UNITED STATES PATENT AND TRADEMARK OFFICE

APPLICATION NO.	FILING DATE	FIRST NAMED INVENTOR	ATTORNEY DOCKET NO.	CONFIRMATION NO.
10/566,865	01/31/2006	Lip Teck Soh	003D.0086.U1(US)	2241
29683	7590	09/18/2006	EXAMINER	
HARRINGTON & SMITH, LLP 4 RESEARCH DRIVE SHELTON, CT 06484-6212			NGUYEN, PHUONGCHI T	
			ART UNIT	PAPER NUMBER
			2833

Office Action Summary	Application No. 10/566,865	Applicant(s) SOH, LIP TECK	
	Examiner Phuongchi Nguyen	Art Unit 2833

DETAILED ACTION

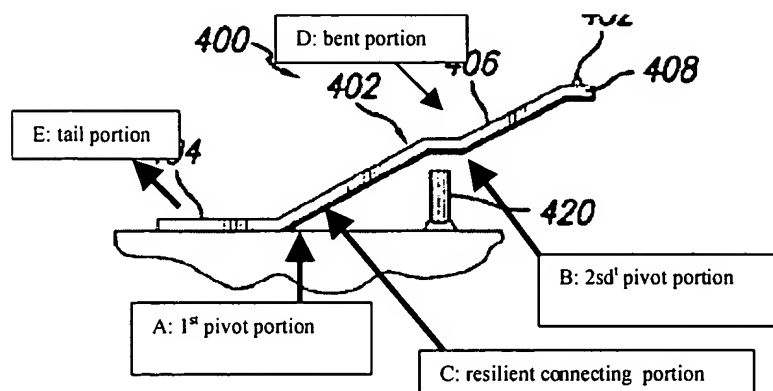
In regards to claim 1, Grube discloses an electrical connector comprising:

a connector housing (416+140); and

at least one deformable connector terminal arrangement (400+416+140) disposed at the connector housing (416+140), the connector terminal arrangement (400+416+140) comprising:

a terminal (400) (figs. 7A-7B) comprising a movable resilient arm portion (402), a contact portion (408) at one end of the resilient arm portion (402) for connecting to a first electrical point (148) (the contact 400 is one of the embodiment of the terminal 130 as seen in fig. 2C) and a support portion (404) connected to another end of the resilient arm portion (402) and for connecting to a second electrical point (122);

a first pivot portion (A) for pivoting of the resilient arm portion (402) relative to the support portion (404); and

a second pivot portion (B) for pivoting of the contact portion (408) relative to the resilient arm portion (402) (see marked-up below).

In regards to claim 2 and 41, Grube discloses the connector wherein the resilient arm portion (402) is operable to deflect about the first pivot portion (A) during movement of the contact portion (408) in a first direction up to a first deflection position, and the contact portion (408) is operable to deflect about the second pivot portion (B) during further movement of the contact portion (408) in the first direction beyond the first deflection position (see marked-up above).

In regards to claim 6, Grube discloses the connector wherein the terminal (400) further comprises the first pivot portion (A), disposed between the resilient arm portion (402) and the support portion (404) (see marked-up above).

In regards to claim 17, Grube discloses the connector wherein the second pivot portion (B) is formed integrally with the resilient arm portion (402) (marked-up above).

In regards to claim 33, Grube discloses the connector wherein the tail portion (E) comprises a first free end of the terminal (400) (see marked-up above).

In regards to claim 38, Grube discloses the assembly wherein the one or more resilient arm portions (402) are pivoted about the respective first pivot portions (A); and the one or more contact portions (408) are pivoted about the respective second pivot portions (B) (see marked-up above).
